**ADMINISTRATIVE SITE PLAN REPORT & VARIANCE REPORT & DECISION**

<b>REPORT DATE:</b>	November 24, 2014
<b>Project Name:</b>	Sunridge Townhomes
<b>Owner:</b>	VY Properties, 15012 SE 253rd Pl, Covington, WA 98042
<b>Applicant/Contact:</b>	Imad Bahbah, IHB Architects, 21620 84th Ave S, Ste. 200, Kent, WA 98032
<b>File Number:</b>	LUA14-001332, SA-A, VAR
<b>Project Manager:</b>	Clark H. Close, Associate Planner

**Project Summary:** The applicant is requesting Administrative Site Plan Review and an Administrative Variance for the construction of two 3-story multi-family structures containing a total of nine (9) townhome units. The site is located at 12228 SE Petrovitsky Road. The existing parcel is 19,889 square feet (sf) and is zoned Residential Multi-Family (RM-F). The proposed buildings would include 6,263 square feet of impervious area and a residential density of 23.3 net dwelling units per net acre (du/ac). The applicant is proposing two affordable housing units and is requesting bonus density in order to achieve a density above the maximum 20 du/acre. The two buildings have a combined area of 18,752 square feet. Access to the site would be gained from SE Petrovitsky Rd via a si

Sunridae Townhomes - Building 1

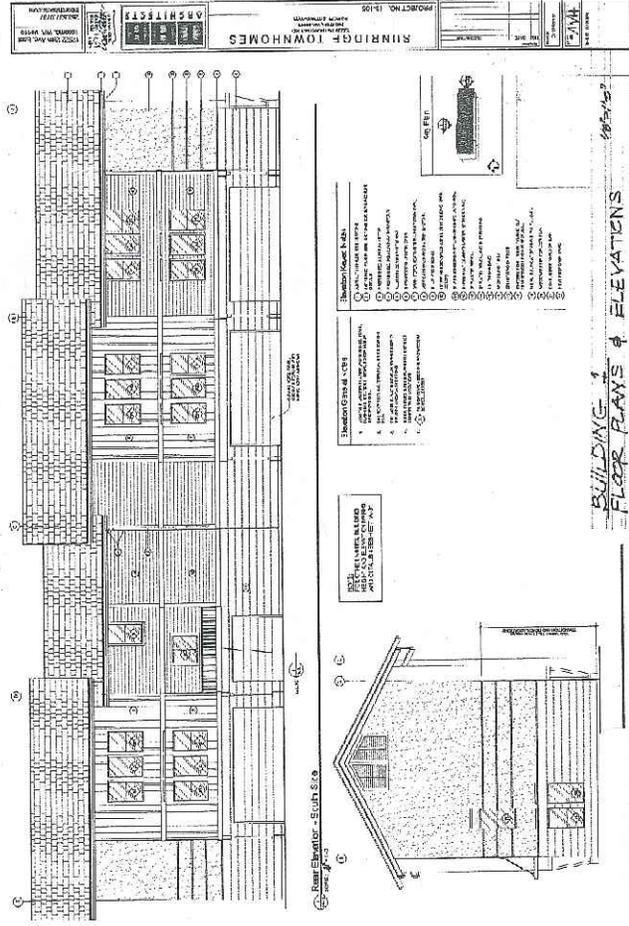
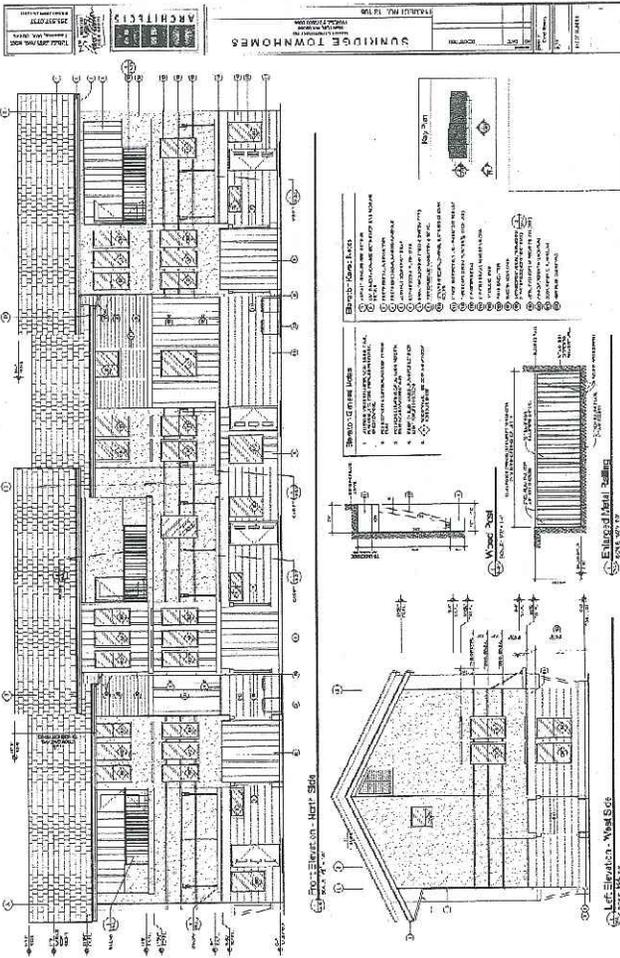
<b>Not compliant</b>	<b>Standard:</b> <i>Any façade visible to the public shall be comprised of at least fifty percent (50%) transparent windows and/or doors for at least the portion of the ground floor facade that is between four feet (4') and eight feet (8') above ground (as measured on the true elevation).</i>  <b>Staff Comment:</b> The current percent of transparent windows and/or doors is roughly around 20%. Staff recommends as a condition of approval that the applicant increase the percentage of transparent windows and/or doors on the north elevation of Building #1 to at least fifty percent between four feet (4') and eight feet (8') above ground elements ( <i>Exhibit 3</i> ).
✓	<b>Standard:</b> <i>Upper portions of building facades shall have clear windows with visibility into and out of the building. However, screening may be applied to provide shade and energy efficiency. The minimum amount of light transmittance for windows shall be fifty percent (50%).</i>

11. Staff recommends as a condition of approval that the applicant increase the percentage of transparent windows and/or doors on the north elevation of Building #1 to at least fifty percent between the height of four feet (4') and eight feet (8') above the ground. The revised north building elevation for Building #1 shall be submitted to and approved by the Current Planning Project Manager prior to building permit approval.

Sunridge Townhomes -- Building 2

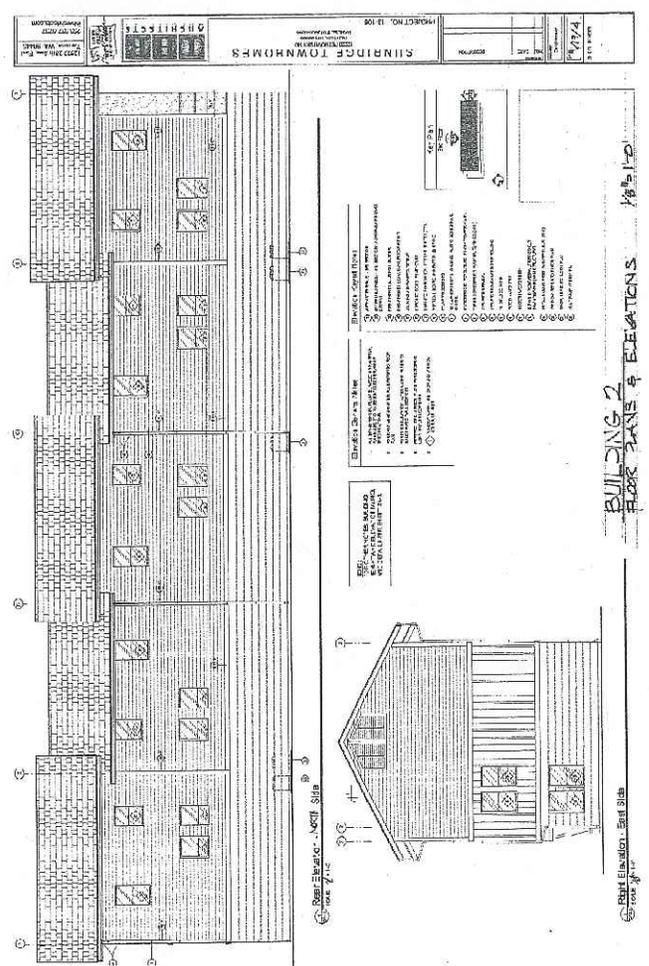
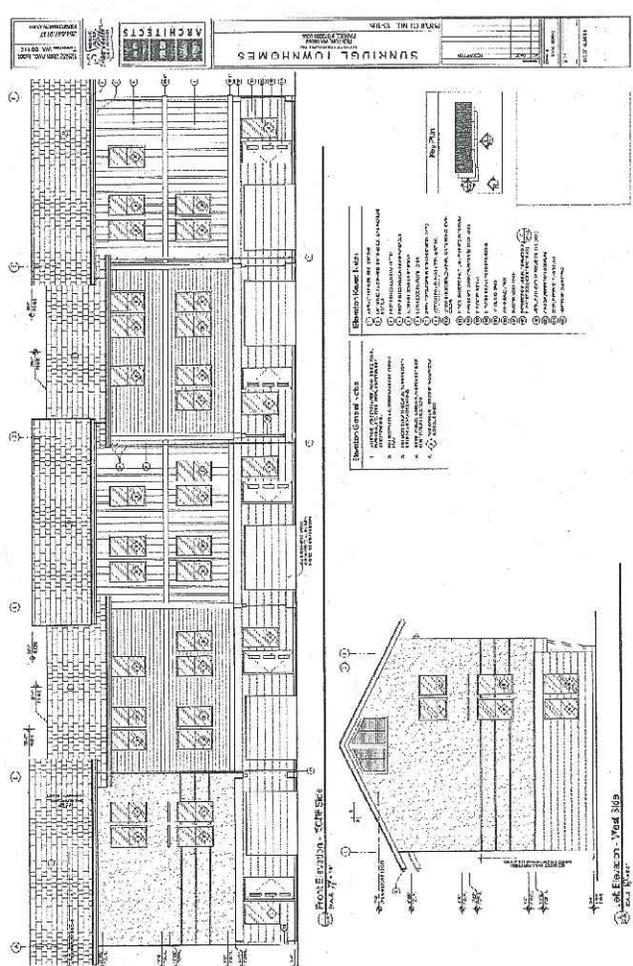
<p><b>Not compliant</b></p>	<p><b>Standard:</b> All building facades shall include modulation or articulation at intervals of no more than 20 feet.</p> <p><b>Staff Comment:</b> Building #1: The north, west and south elevations are visually interesting with elements of building modulation and articulation. The east elevation has somewhat less modulation and articulation than the rest of the building (<i>Exhibit 3</i>).                  Building #2: The south elevation includes horizontal modulation between the first and</p>

second floor, different colors and materials to reduce the apparent bulk and scale of the building, distinctive window patterns and rooflines, and articulation of the building top, middle and bottom. The west, north and east elevations have no vertical or horizontal modulation and limited articulation to reduce the apparent size and bulk of the new building located near the apartments to the north. Staff recommends as a condition of approval that the applicant add elements of building modulation and/or additional elements of articulation to the north elevation of Building #2, such that it is similar in scale and design of that found on Building #1 ( <i>Exhibit 3</i> ).
✓	<b>Standard:</b> <i>Modulations shall be a minimum of two feet (2') in depth and four feet (4') in width.</i>
N/A	<b>Standard:</b> <i>Buildings greater than one hundred sixty feet (160') in length shall provide a variety of modulations and articulations to reduce the apparent bulk and scale of the façade; or provide an additional special feature such as a clock tower, courtyard, fountain, or public gathering area.</i>

10. The applicant shall add elements of building modulation and/or additional elements of articulation to the north elevation, ground floor façade, of Building #2 that are similar in scale and design found on Building #1. This may include, but is not limited to, adding doors, balconies, awnings, or bay windows. The applicant shall submit to, and have approved by, the Current Planning Project Manager, the revised elevation plans prior to or concurrent with building permit approval.
